HYUNDAI
Technical Service Bulletin

GROUP AUTOMATIC TRANSMISSION	NUMBER 23-AT-011H
DATE AUGUST 2023	MODEL(S) SANTA FE (TMa) SONATA (DN8a) SANTA CRUZ (NXT)

SUBJECT: 8-SPEED WET DCT REPLACEMENT INSTRUCTIONS FOR 2.5T
VEHICLES

Male terminal of TCU

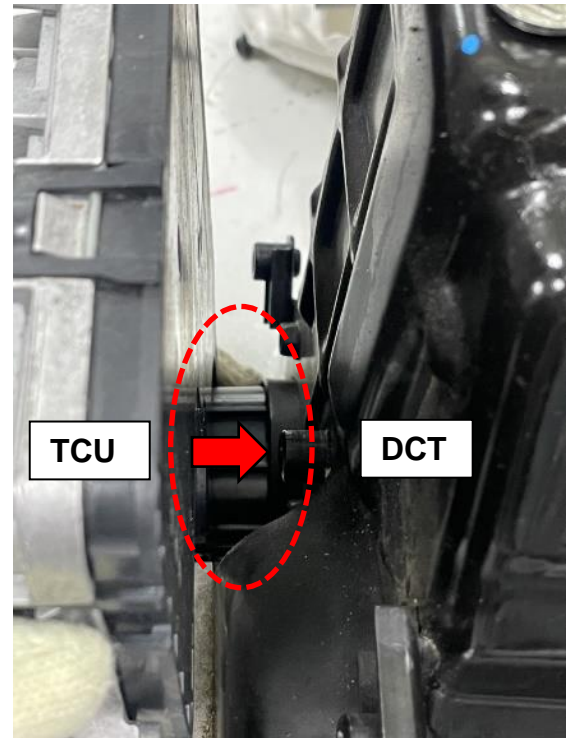
Make sure the TCU 24-pin terminal is aligned properly during removal/installation, otherwise the pins may get damaged.

2. When reinstalling the TCU, make sure to align the connector on the TCU to the E-module on the DCT.
